CHANGE ORDER

Project: Woodland High School Project No.: 1119.00-12
 Architect: McGranahan Architects Change Order No.: 2
 Contractor: Skanska USA Building, Inc. Date: February 9, 2014

CONSTRUCTION CHANGE DIRECTIVE: 002 R1

Woodland High School

TITLE: PARTIAL FDN PLAN - MUSIC-DRAMA
 REFERENCE: S2.14
 SCALE: 1/8" = 1'-0"
 ISSUED FOR: RFI-041
 DATE: 01.09.14

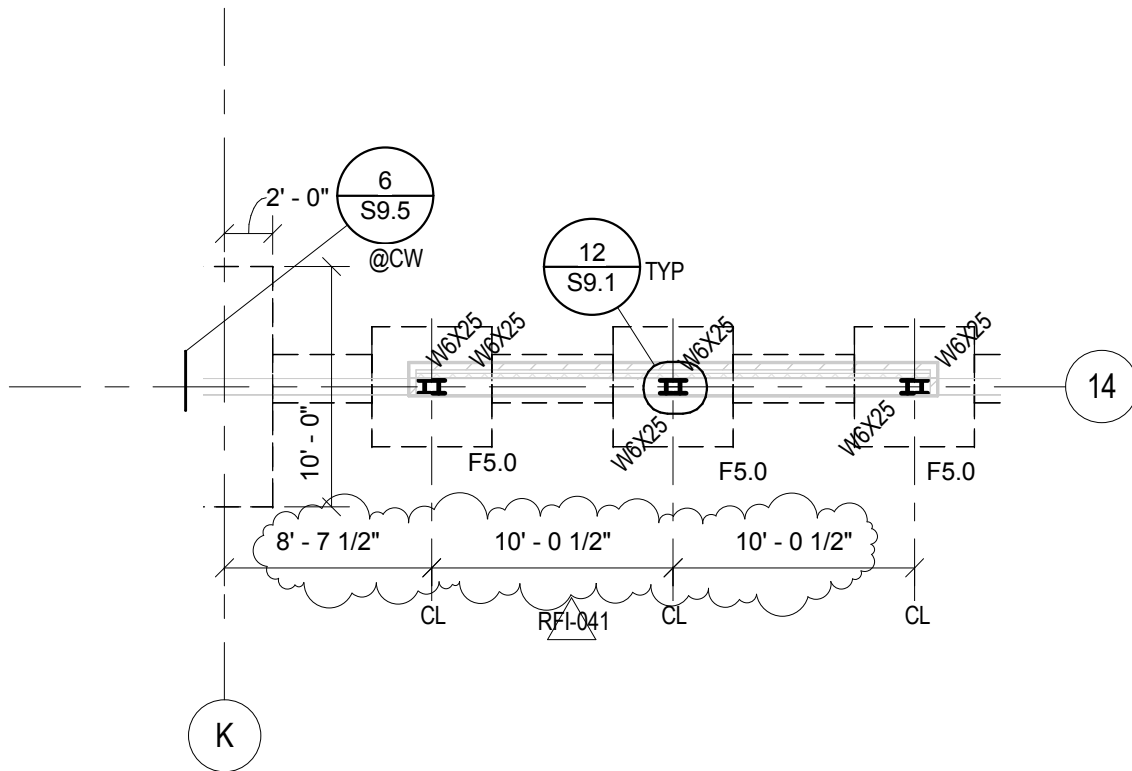
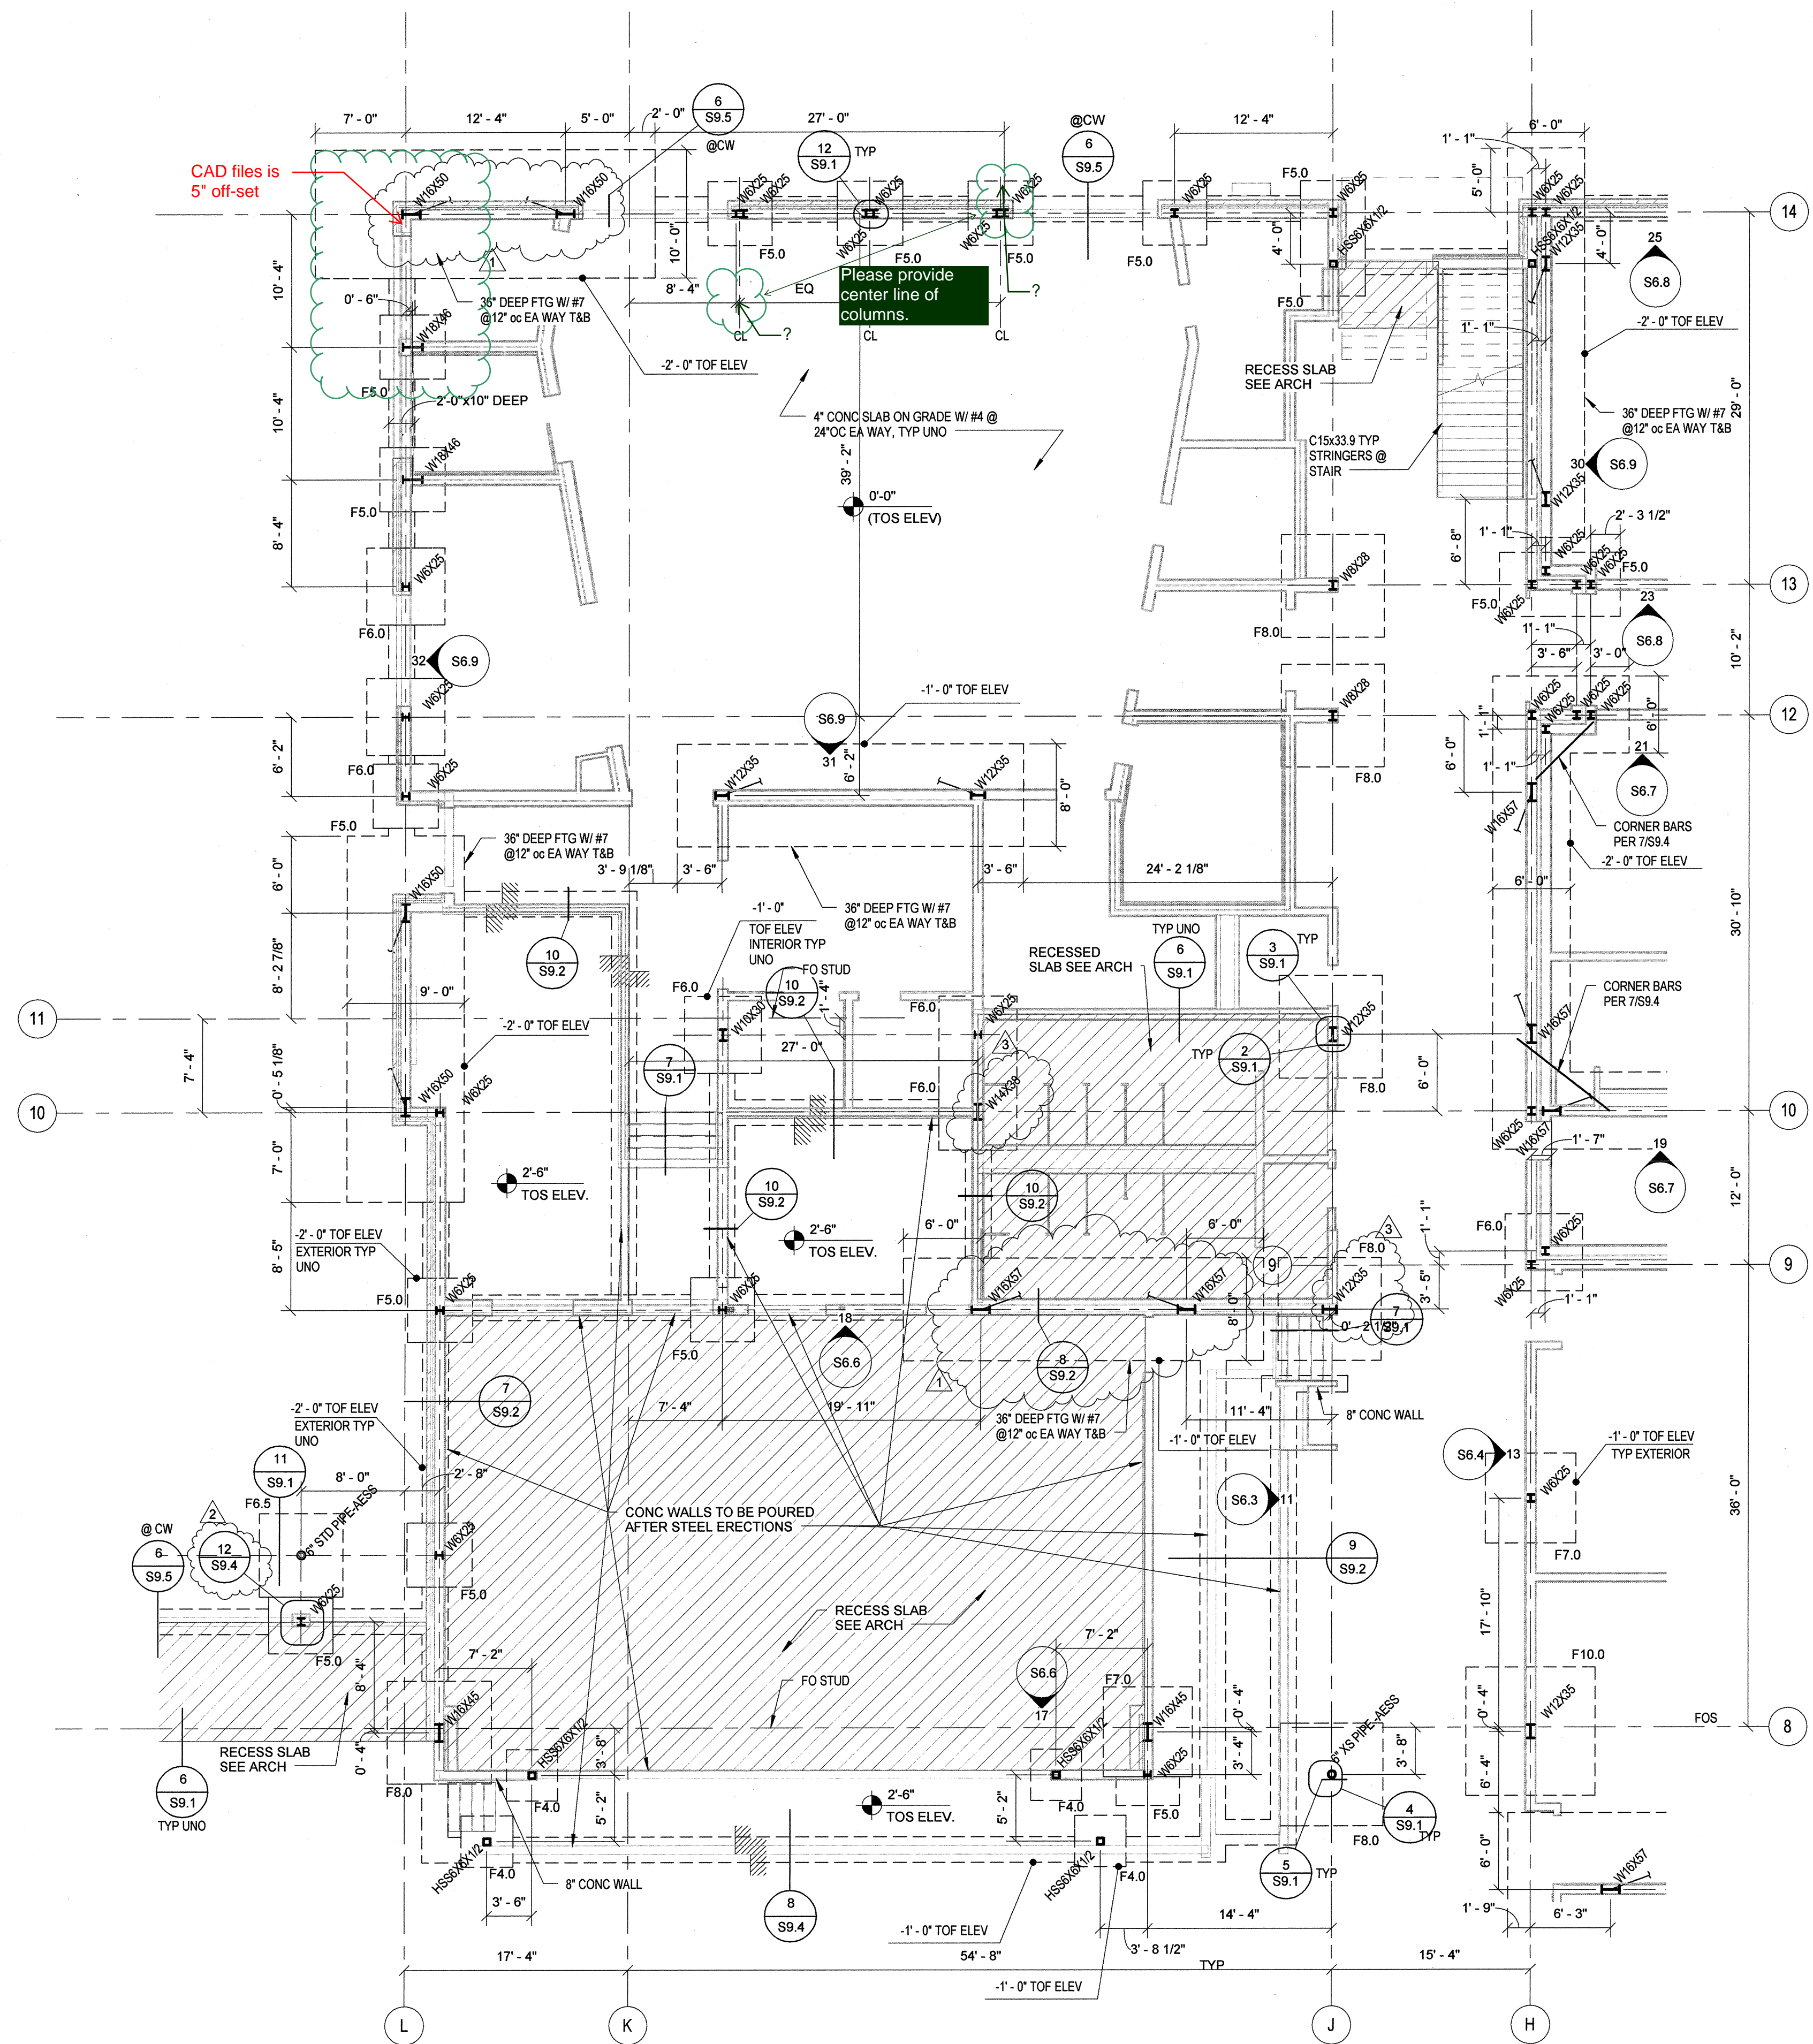
Reference sheet S2.14, columns at gridline 14 and J.8 line.

See attached sketch SSK-053 for updated dimensions to centerline of the double W14x43 at this location.

TITLE: PARTIAL FDN PLAN - MUSIC-DRAMA
 REFERENCE: S2.14
 SCALE: 1/8" = 1'-0"
 ISSUED FOR: RFI-042
 DATE: 01.09.14

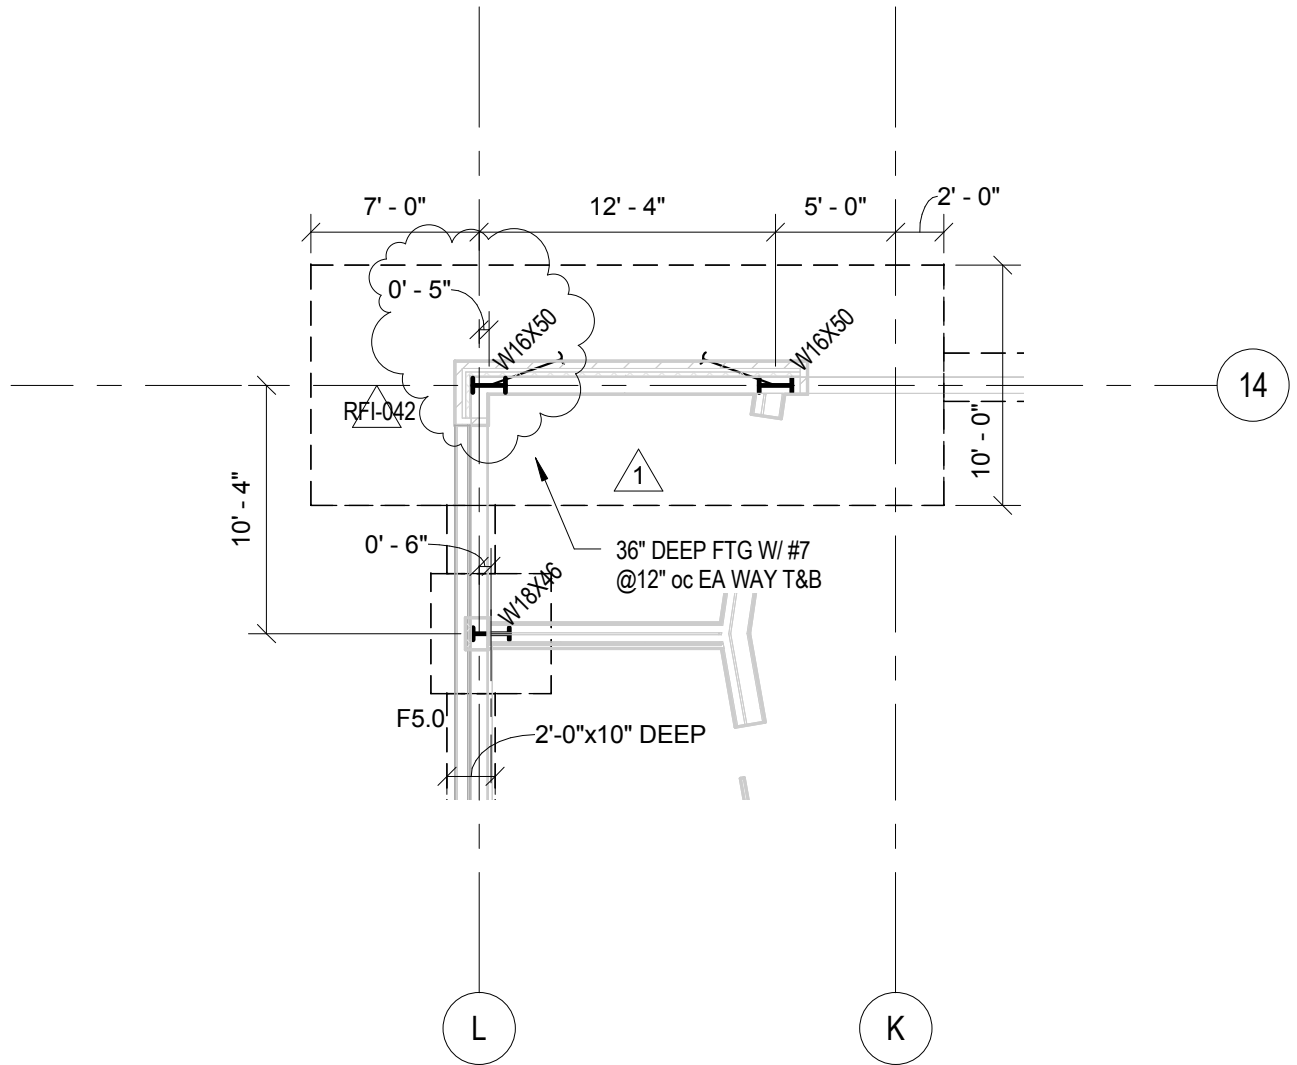
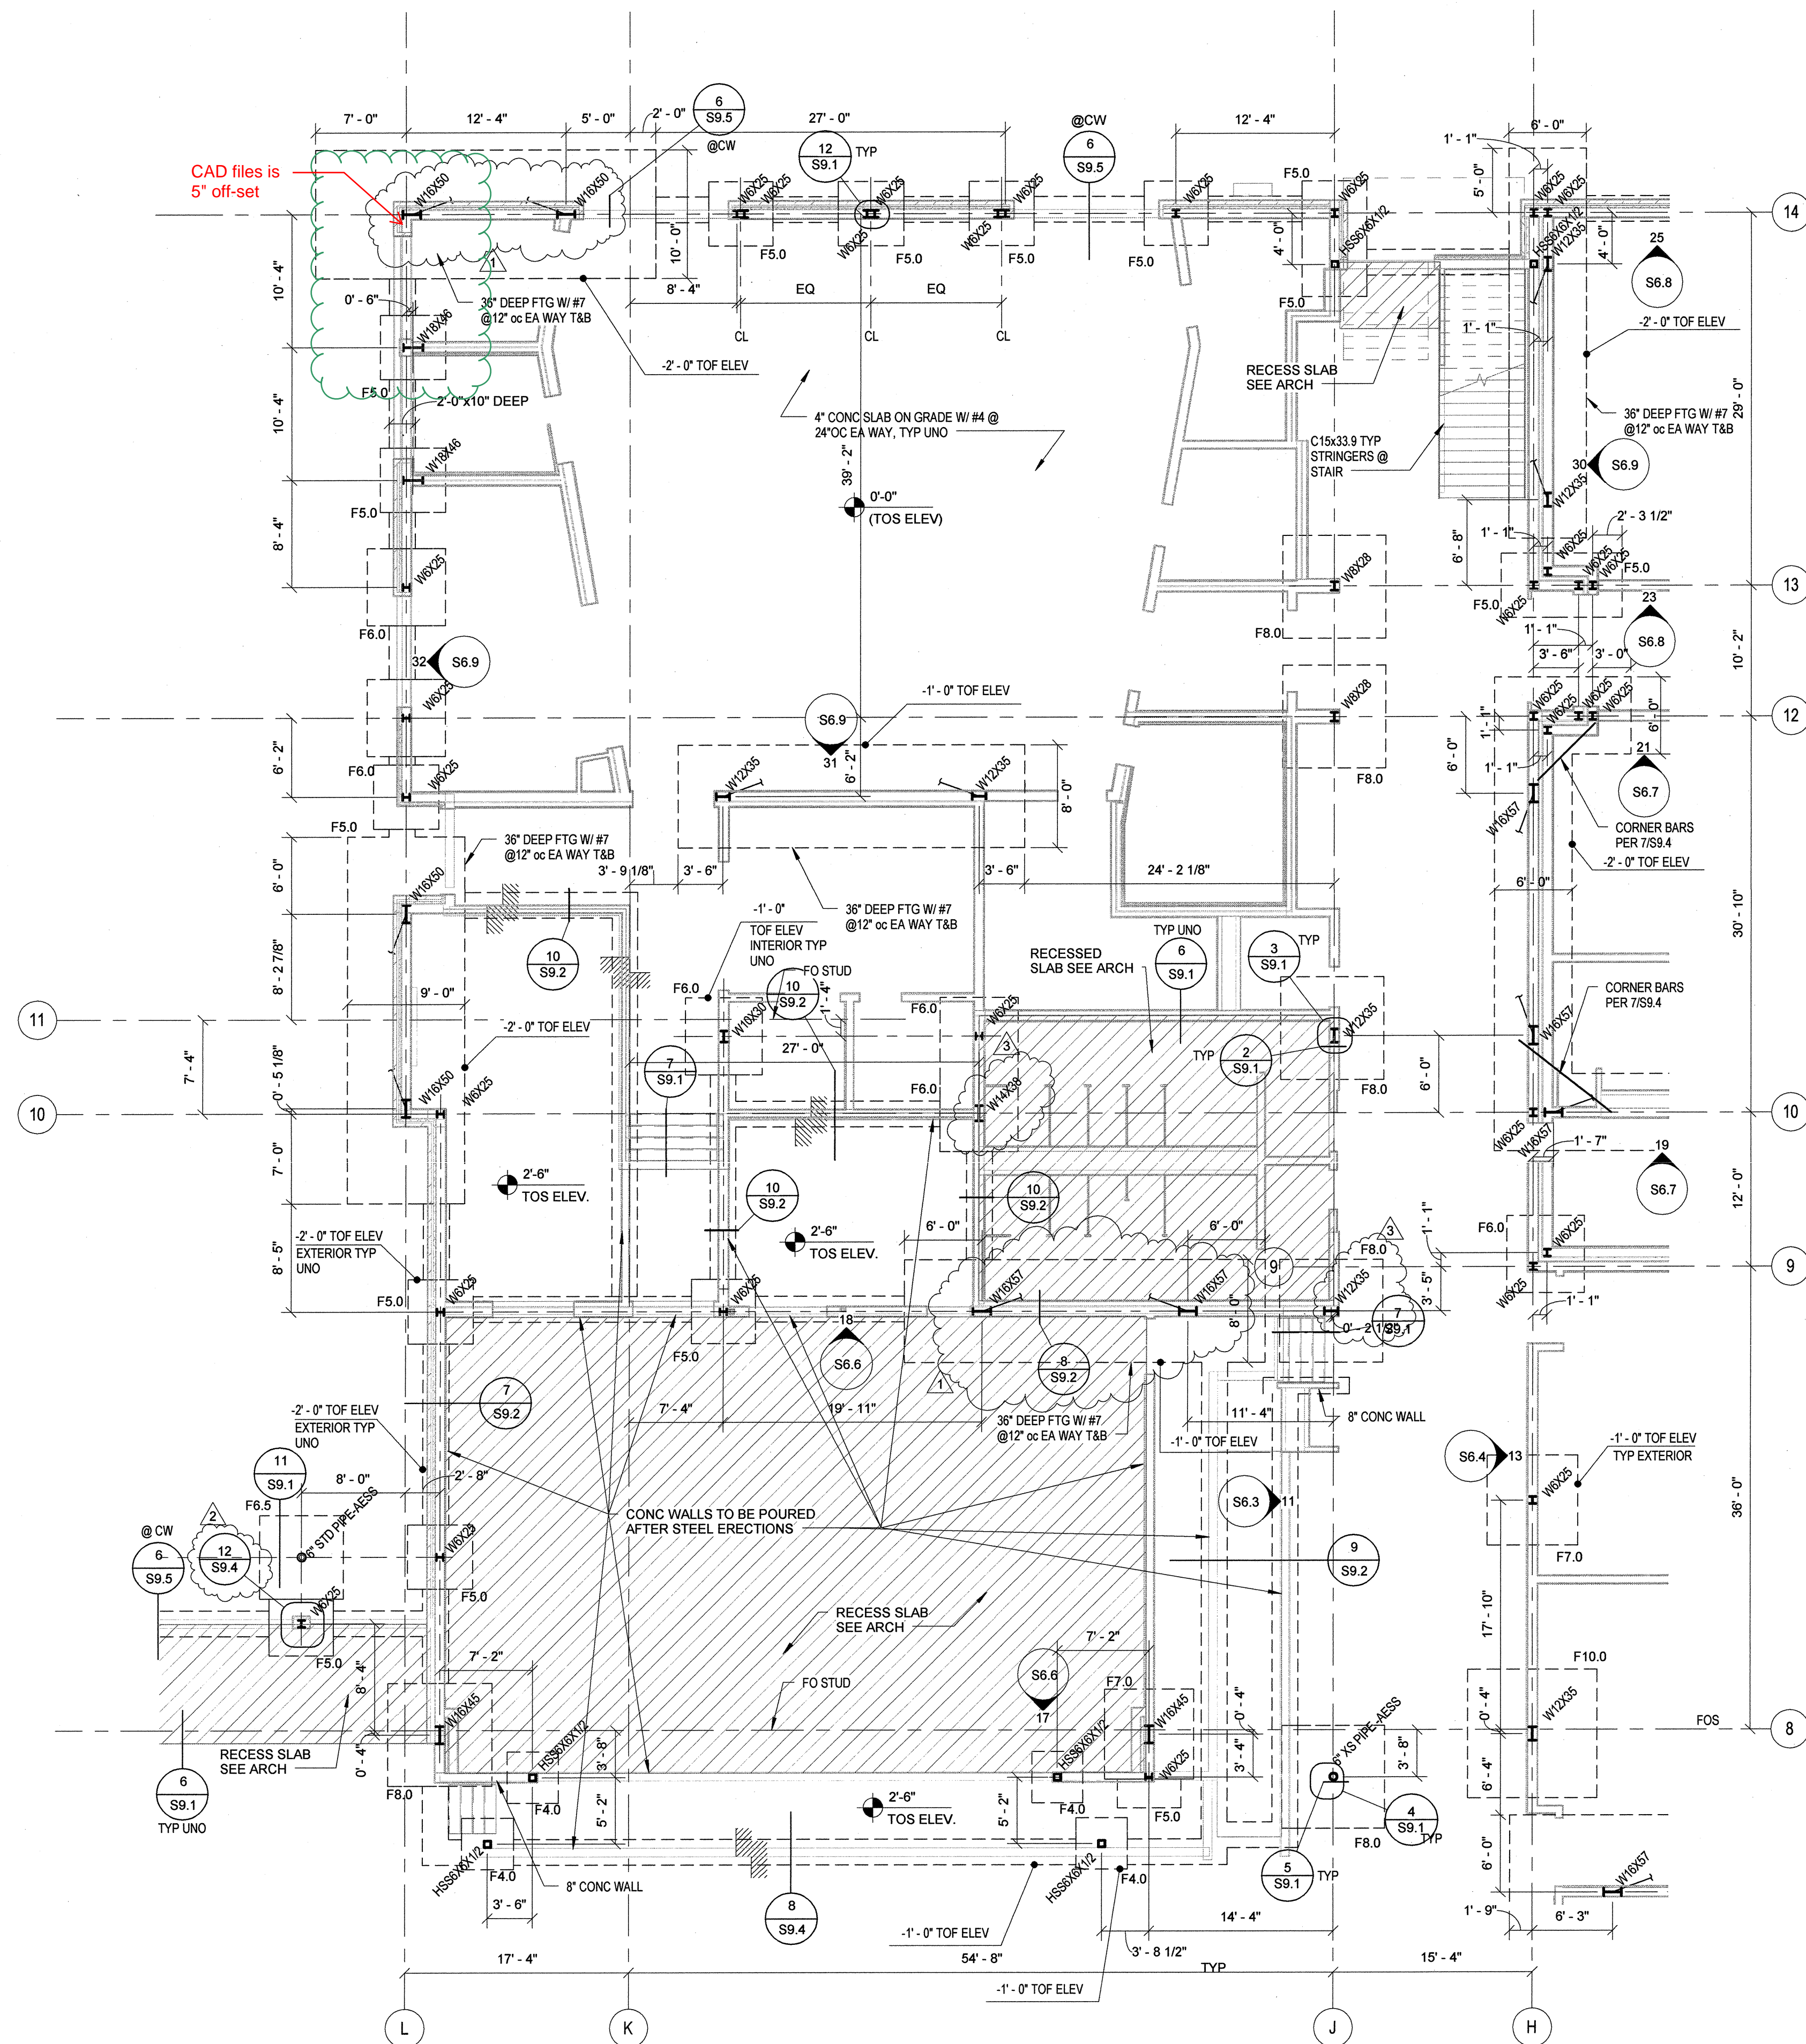
Reference sheet S2.14, column at the corner of grid line L/14.

There is a 6" dimension to center line of the columns along grid line L. However, the corner column graphically looks like it is different than 6". Please provide a center line dimension to the W16X50 column at grid line L/14 if required.

See attached sketch SSK-054 for updated dimensions to centerline of the W16x50 at this location.
